TRANSMISSION—4R100—DELAYED OR NO 2ND GEAR—DIAGNOSTIC TROUBLE CODES P0781, P0755 AND/OR P0756—VEHICLES EQUIPPED WITH 4R100 TRANSMISSION WITH TRANSMISSION BUILD DATES BETWEEN 7/27/2000 AND 3/23/2001 ONLY

Article No. 01-13-5

FORD: 2001 E SERIES, EXCURSION, EXPEDITION, F-150, SUPER DUTY F SERIES, SUPER DUTY F-53 STRIPPED CHAS.

Figure 1 - Article 01-13-5

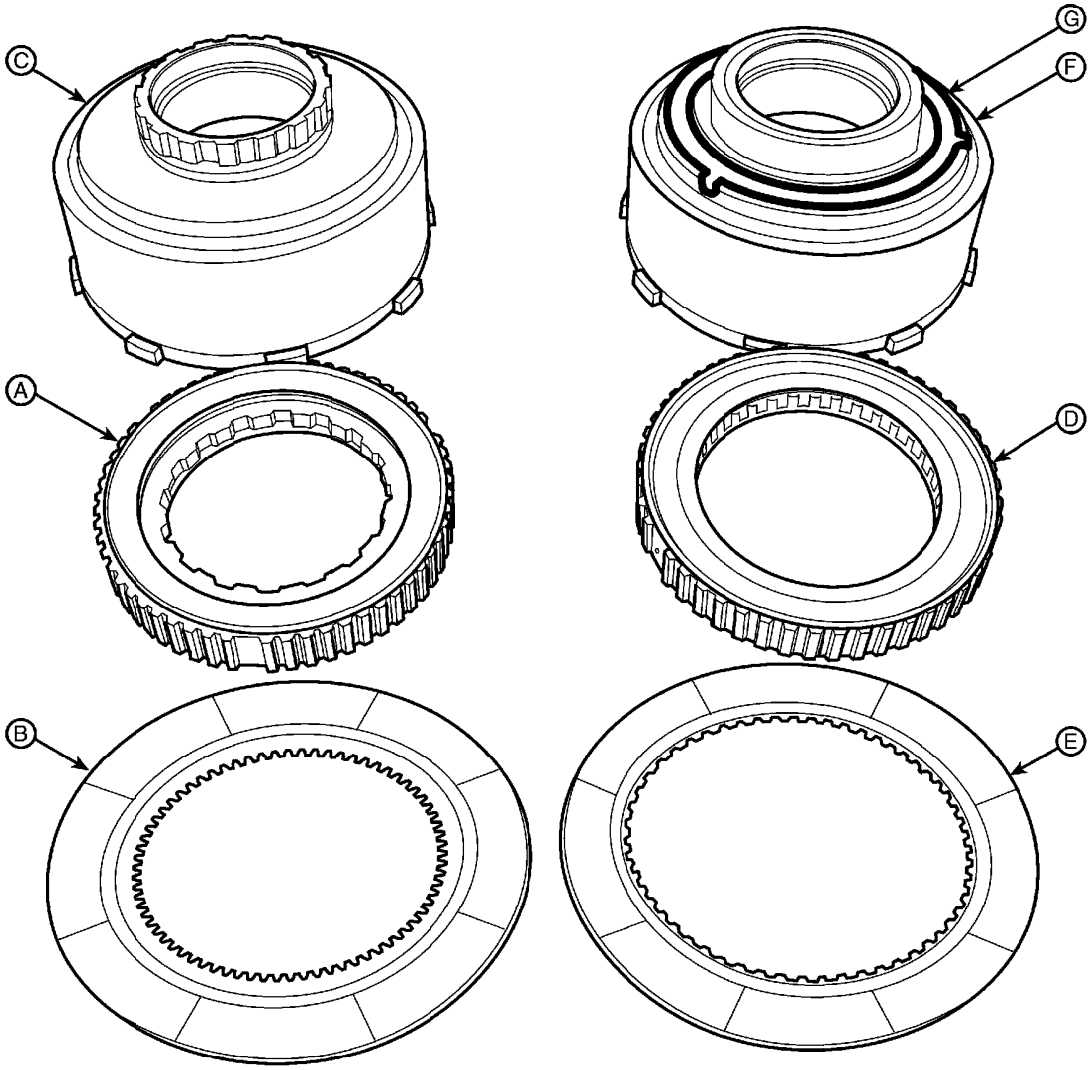
Verify condition, follow normal diagnostics per the appropriate Workshop Manual. If diagnostics leads to the described condition, replace the Intermediate One Way Clutch (OWC) (mechanical diode style 7A089), Intermediate Brake Drum (7D044) and Intermediate Clutch internally splined friction plates (7B164). Refer to the following Service Procedure for details.

MAKE SURE ALL MATING COMPONENTS LISTED ARE CHANGED. THE MATING COMPONENTS OF THE TWO DESIGN ONE WAY CLUTCHES (7A089) ARE NOT INTERCHANGEABLE. IF ALL THE COMPONENTS ARE NOT CHANGED, INTERNAL TRANSMISSION DAMAGE MAY RESULT.

THE MECHANICAL DIODE DESIGN ONE WAY CLUTCH, DID NOT USE A #7 THRUST WASHER. THERE ARE NO MACHINED SLOTS IN THE INTERMEDIATE BRAKE DRUM FOR THE THRUST WASHER TABS. THE SPRAG DESIGN ONE WAY CLUTCH MUST BE USED WITH A #7 THRUST WASHER. THE INTERMEDIATE BRAKE DRUM USED WITH THE SPRAG OWC DESIGN HAS SLOTS MACHINED IN THE DRUM FOR THE #7 THRUST WASHER TABS.

REMOVE
MECHANICAL DIODE ONE-WAY CLUTCH (OWC)
DESIGN COMPONENTS

INSTALL
SPRAG ONE-WAY CLUTCH (OWC)
DESIGN COMPONENTS
